**VIRGINIA ELECTRIC AND POWER COMPANY (DOMINION)**  
**DOMINION NUCLEAR CONNECTICUT, INC. (DNC)**  
**NORTH ANNA AND SURRY POWER STATIONS UNITS 1 AND 2**  
**MILLSTONE POWER STATION UNITS 2 AND 3**  
**APPROVED TOPICAL REPORT DOM-NAF-2, REV 0.0-A**  
**REACTOR CORE THERMAL-HYDRAULICS USING THE VIPRE-D COMPUTER CODE**  
**INCLUDING APPENDIXES A AND B**

**Topical Report DOM-NAF-2, Rev. 0.0-A**

**REACTOR CORE THERMAL-HYDRAULICS USING THE  
VIPRE-D COMPUTER CODE**

**Fleet Report  
DOM-NAF-2,  
Rev. 0.0-A  
(with Appendixes A & B)**

Figure 1: Locked Rotor Transient Equilibrium Quality Results at Time 3.0 Seconds

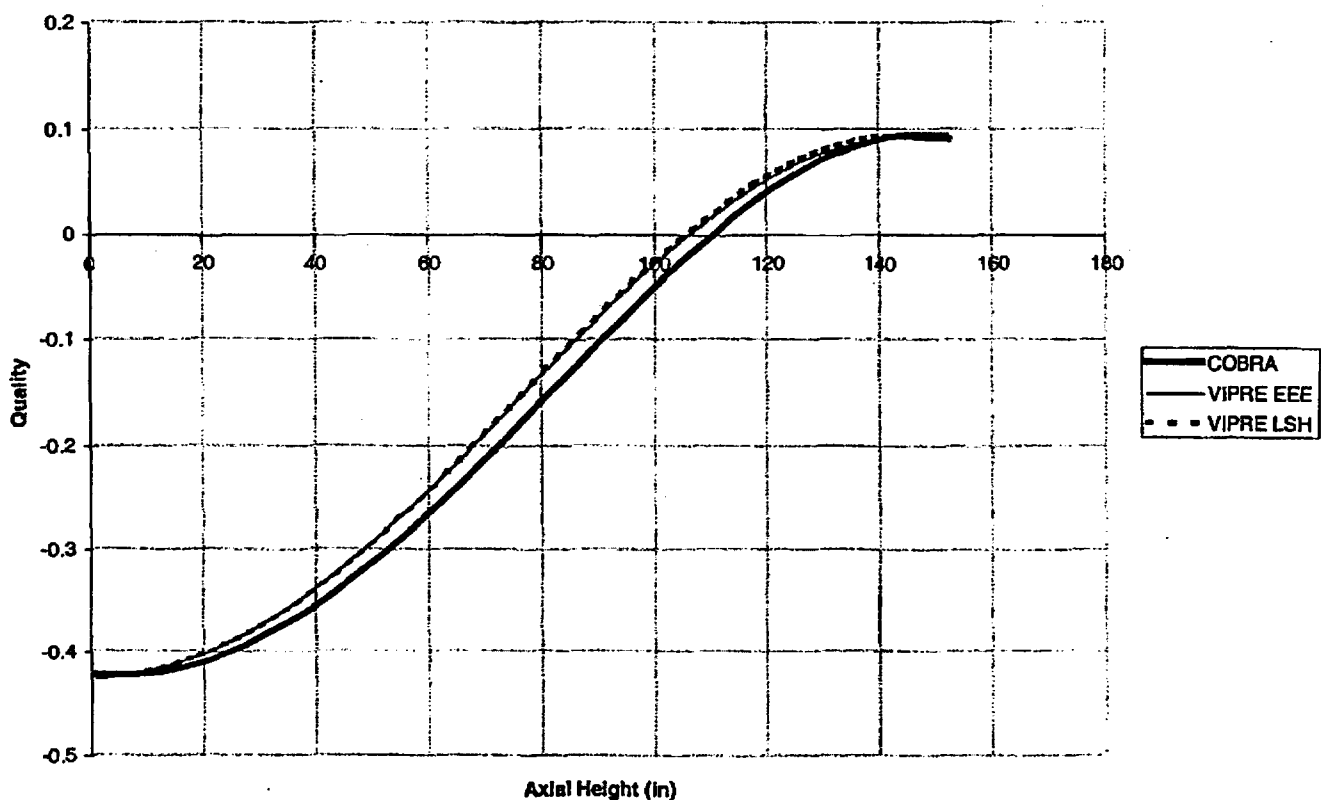
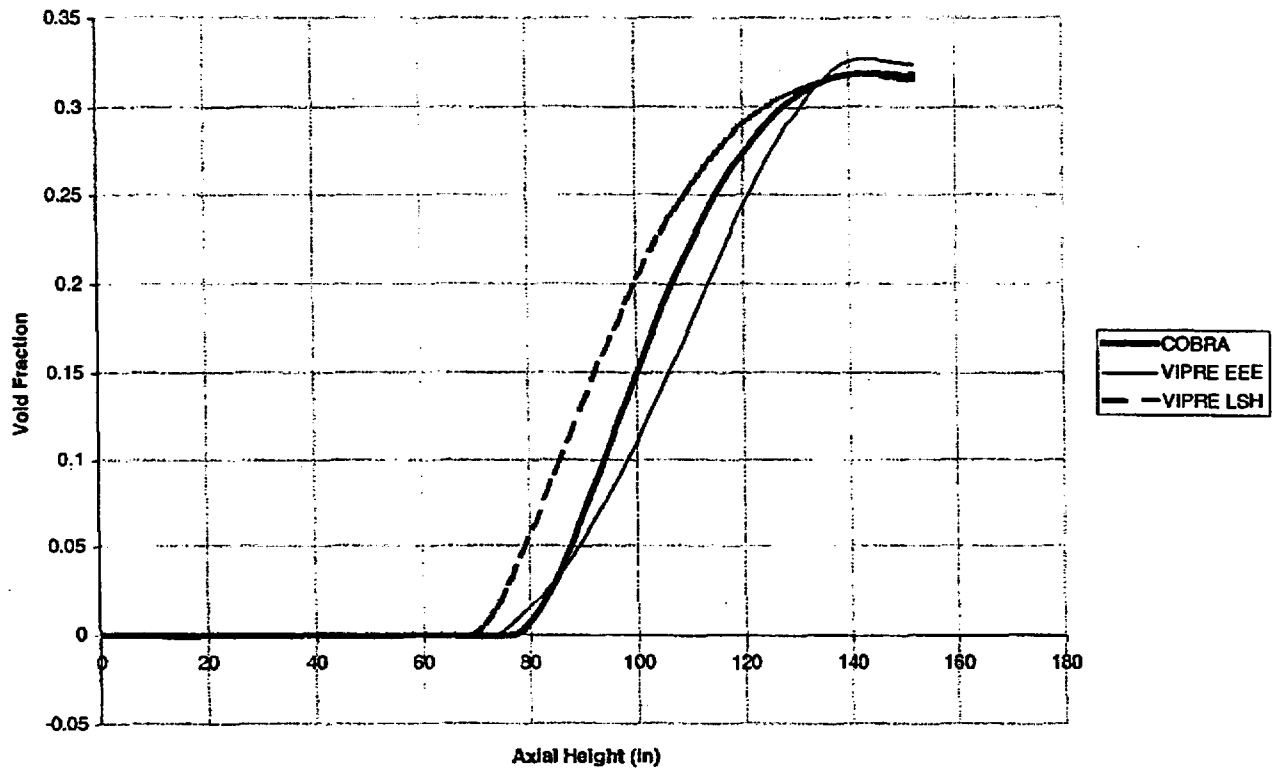
***NRC Question 1***

During the May 25, 2005 NRC-Dominion public meeting, Dominion agreed to provide some graphic comparisons to show VIPRE-D's performance for void fraction and quality. Figures 1 and 2 provide a comparison between the VIPRE-D/WRB-1 and the COBRA/WRB-1 codes. In particular, these figures show the void fraction and quality axial distributions in the hot channel at the time of minimum DNBR (3.0 seconds) for a Locked Rotor Transient event at Surry Power Station. Additional description and results associated with this transient were included in Section B.7.3 of Appendix B to DOM-NAF-2. In addition to the VIPRE-D/WRB-1 with the EPRI-EPRI-EPRI set of models, Figures 1

Figures 1 and 2 show that the different void and two-phase friction models result in comparable void fraction and quality trends for COBRA and VIPRE-D. However, as noted above, DNBR comparisons are the main criterion used to evaluate the performance of VIPRE-D against other thermal-hydraulics codes and models. These comparisons demonstrated the acceptability of the EPRI models for bulk void, subcooled void and two-phase friction factor for use in the Dominion VIPRE-D models.
